PLANNING REPORT

Planning and Zoning Commission

Dublin Scioto High School 25-029AFDP

Address	4000 Hard Road Dublin, OH 43016
Proposal	Proposal for an Amended Final Development Plan for minor site improvements to a multipurpose sports field.
Request	Request for review and approval of an Amended Final Development Plan under the provisions of Zoning Code Section 153.055.
Zoning	PUD - Planned Unit Development District: NE Quad
Planning Recommendation	<u>Approval of an Amended Final Development Plan with Condition.</u>
Next Steps	Upon receiving approval from the Planning and Zoning Commission (PZC), the applicant may work through the condition of approval with staff, then they may apply for permits through Building Standards.
Applicant	Megan Cyr, The Kleingers Group
Case Manager	Taylor Mullinax, AICP, Planner I (614) 410-4632 tmullinax@dublin.oh.us

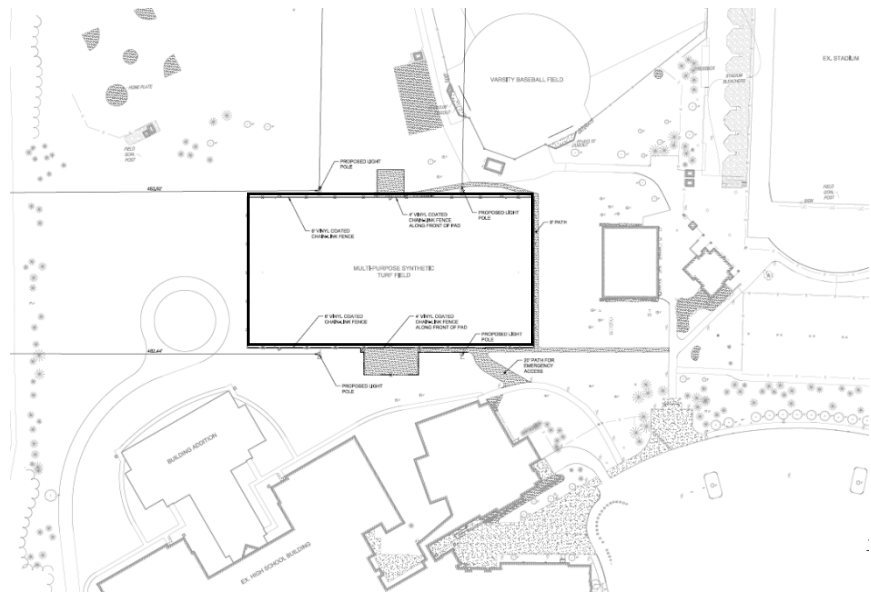
The proposed hardscaping includes new concrete walkways on the north, east, and south sides of the multi-purpose field, as well as pads for portable bleachers on the north and south sides. These improvements will add a total of 9,961 square feet (0.23 acres) of pavement to the site. A portion of the walkway is designed to be wider than other sections to accommodate maintenance equipment and emergency vehicle access to the field. All additional sidewalks and pads are to access the sport fields, as well as equipment and seating needed to use the fields.

The proposed light poles include four new 70-foot light poles positioned on the north and south sides of the multi-purpose sports field. The poles are set back 482 feet from the western property line and 566 feet from the northern property line and meet the required setback

The site contains existing fencing including but not limited to surrounding the stadium, tennis courts, softball, and baseball fields. The proposed fencing will consist of a 6-foot black vinyl-coated chain link fence mounted on galvanized metal posts, enclosing the multi-purpose sports field. Portions of the fence in front of the bleacher pads will be reduced to 4 feet in height to maintain visibility and accessibility. The proposed fencing matches the existing fencing and is used throughout all of the three high schools.

The applicant is proposing a maximum lot coverage of 46.83 percent, which includes the recently approved building additions, and the impervious surface proposed with this application. This exceeds the maximum permitted lot coverage of 45 percent. Staff recommend reducing the amount of proposed hardscaping around the multi-purpose sports field to comply with the maximum lot coverage. A condition of approval has been included to reflect this recommendation.

- 1) The applicant submits revised plans with a portion of the proposed hardscape removed to meet the maximum permitted lot coverage, subject to staff review and approval, prior to building permitting.
